# INSTALLATION OF NEW ROOF MOUNTED PV SOLAR SYSTEM

54 DOLORES DRIVE  
EDISON, NJ 08817

Drawing Title:
AS BUILT PV SOLAR SYSTEM

# APPLICATIONS CHANGE

Rev. No.	Sheet
A2	PV - 2

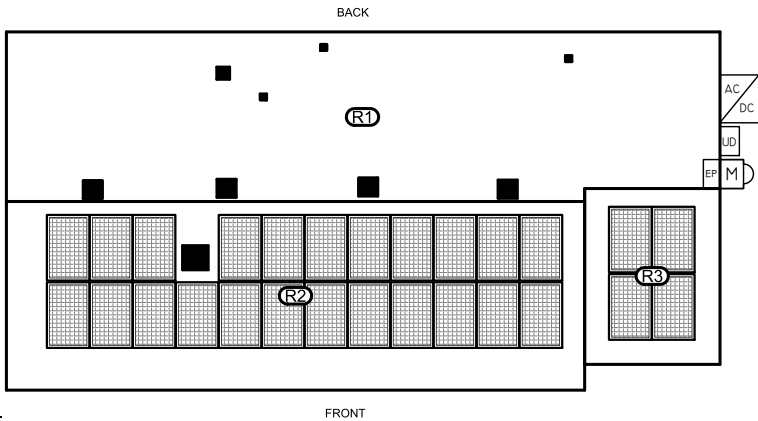
-ADDED 2 MODULES TO SYSTEM  
-ADDED 2 MODULES TO ROOF 2

=MODULE CHANGE FROM HANWHA 315 TO  
HANWHA 295  
-DC SYSTEM SIZE INCREASE FROM 7875W TO  
7965W
